**GLENORCHY PLANNING AUTHORITY MEETING
AGENDA
MONDAY, 6 NOVEMBER 2023**

**5. PROPOSED USE AND DEVELOPMENT - MULTIPLE DWELLINGS
(ONE EXISTING TWO PROPOSED) - 36 GROVE ROAD
GLENORCHY**

Application No.:	PLN-23-083
Applicant:	MinD Architects
Owner:	Tant Holdings Pty Ltd
Zone:	Inner Residential Zone
Use Class	Residential
Application Status:	Discretionary
Discretions:	<p>9.4.2 (P3) Setbacks and building envelope for all dwellings</p> <p>9.4.3 (P2) Site coverage and private open space for all dwellings</p> <p>9.4.6 (P1) Privacy for all dwellings</p> <p>C2.5.1 (P1) Car parking numbers</p> <p>C9.5.2 (P1) Sensitive use within an attenuation area</p> <p>C12.6.1 (P1.1) and (P1.2) Buildings and works with a flood-prone hazard area</p> <p>(The proposal meets all other applicable standards as demonstrated in the attached appendices)</p>

Figure 3. Markup showing the area which protrudes from the envelope as viewable at the south east elevation.

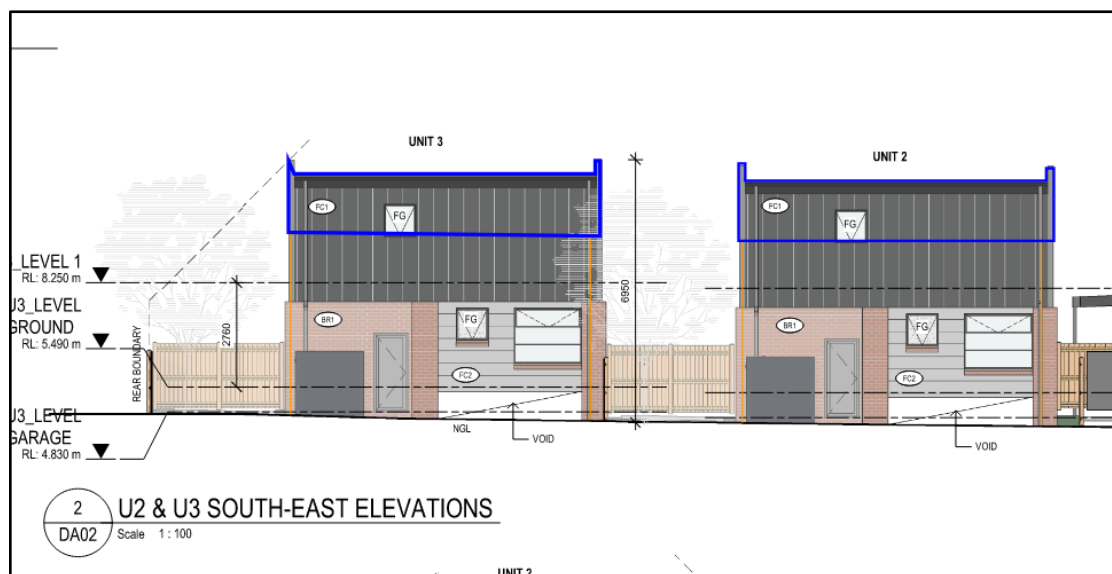
The proposed dwellings, by virtue of their building height (6950mm), and setback of approximately (1800mm) each protrude from the building envelope as defined by the south east boundary, approximately 1.6m (see figure 3).

The uniform protrusion of 1.6m for each dwelling is excessive, noting at least 400mm in height is a result of the raised finished floor level in being a response to the flood prone nature of the site. This height presents to the adjoining property at 34 Grove Road most significantly, though will be somewhat present viewing the site heading west on Grove Road. The protrusion is considered immoderate with respect to the visual impact it creates for the adjoining property. The design lacks attributes which

With respect to those other points within the criteria to have regard for, it is considered that though the overshadowing is not excessive, and though the dwelling separation is not inconsistent, still the proposal by virtue of its height, causes an unreasonable loss of amenity to the adjoining property to the south due to the apparentness of the scale of the proposal, its bulkiness and general inconsistency. The proposal does not comply with the performance criteria.

Figure 5. Extract of site plan.

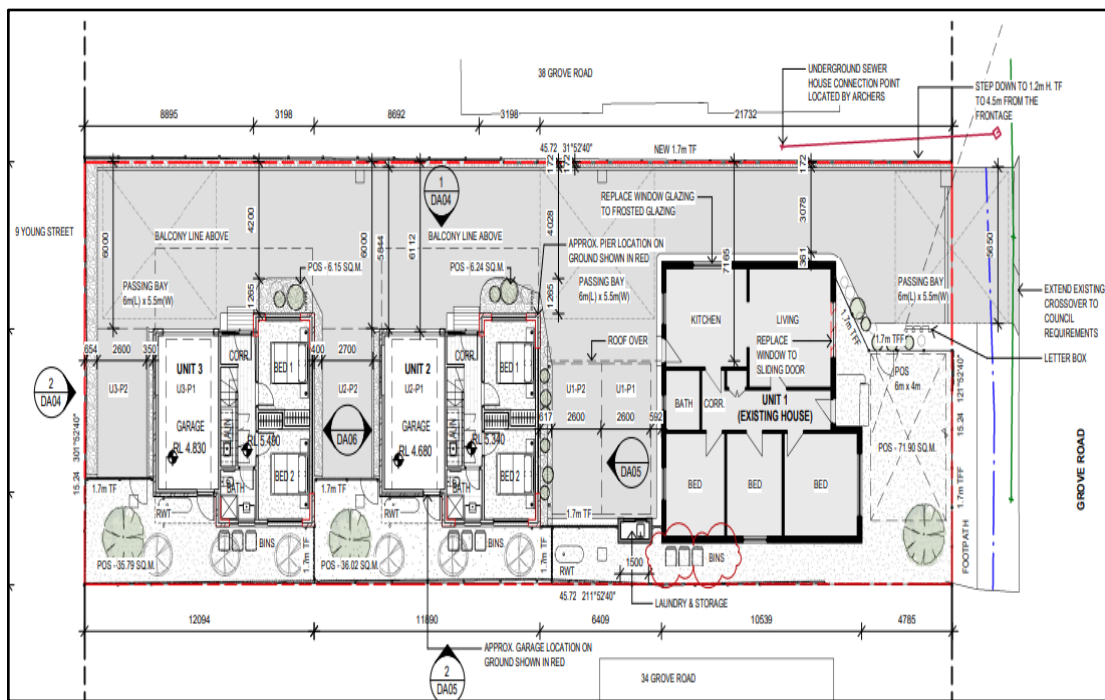
The development application seeks an approval to construct two additional residential dwellings which will make the total of three dwellings including the existing. The works proposed include widening to the crossover and works associated with driveway and parking areas for six car spaces.

Based on the report findings that within the site velocities up to 1.9 m/s and depths up to 0.55 m are observed, the existing hazard therefore falls on the hazard level H3 which is unsafe for vehicles, children and elderly. The application and the report have been referred to Council's Senior Civil Engineer to review, provide comments and recommend the conditions as required.

Upon reviewing the information and from the discussion with the applicant and engineers, it is our view that the application fails to demonstrate compliance with the applicable standards of the Flood-Prone Hazard Area code. It is therefore recommended that the application shall be **refused**. Further discussion and consideration are provided in the following section under section C12.0.

Figure 8. Pre development Flood Hazard Extents.

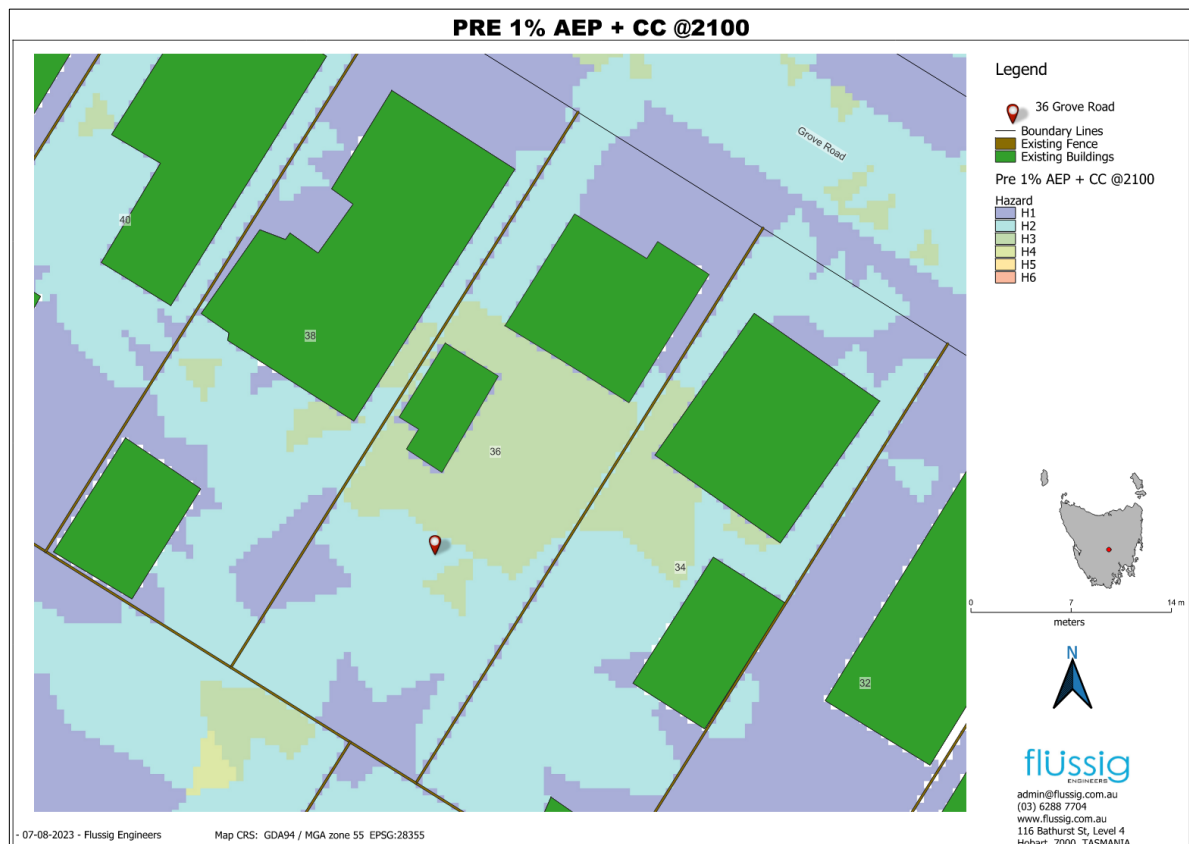
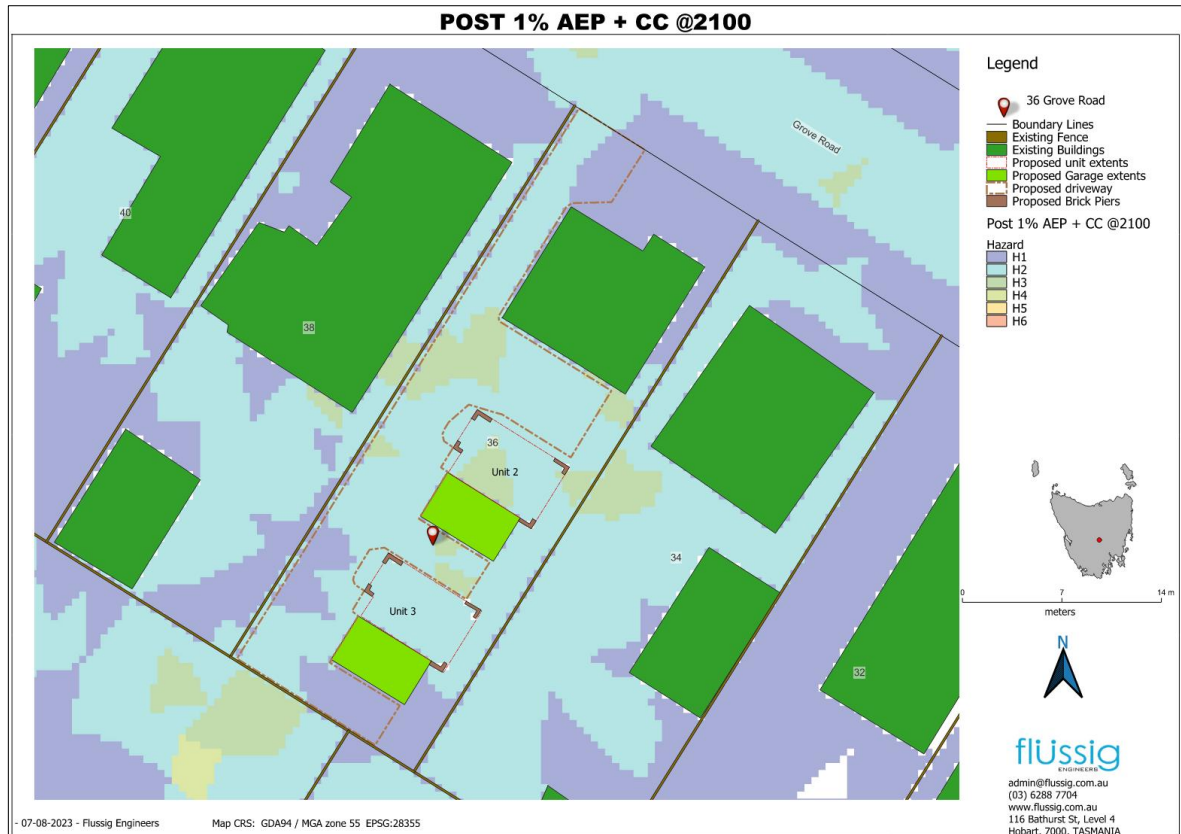
Flussig report has identified moderate flood hazard extents within the lot and neighbouring lots in the model. In particular, the backyards are already exposed to up to **'H3 hazard category, which is unsafe for vehicles, children, and elderly'**. Upon post development, the report indicates that most of the lot is still at **'H2-unsafe for small vehicles'**, while few sections including the shared driveway – the only access and egress point to the new units still remains at H3 category.

Flussig report has concluded that due to the moderate risk present, the location is deemed **unsafe for vehicles, children and elderly**. Furthermore, the report states that the access to the new units at the back will be hindered during a 1% AEP flood event and, thus the occupants will be restricted to inside of the buildings.

Due to the restricted size of the lot, it is apparent that it is nearly impossible to achieve a safer and tolerable flood risk to the proposed development. Accordingly, Flussig report has provided a range of recommendations including:

The proposed development cannot therefore safely achieve and maintain a tolerable flood risk in its current configuration because it would expose critical areas to unsafe flood risks, making it difficult to evacuate occupants during a flood, and cause additional property damage.
